## PRODUCT BULLETIN # 20054

**Issue Date:** 05-Apr-2013

**TITLE:** Announcement of character missing on MPN Label

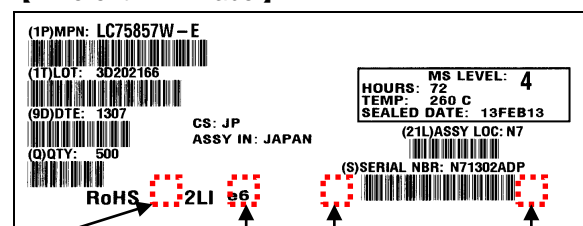
In this affected period, the following characters are missing due to the printing failure of MPN Label. There is no problem for other data at all.

The items which have missing characters of MPN Label are as follows;

1. Pb-Free
2. E-Category Value
3. China RoHS
4. ON Semi logo
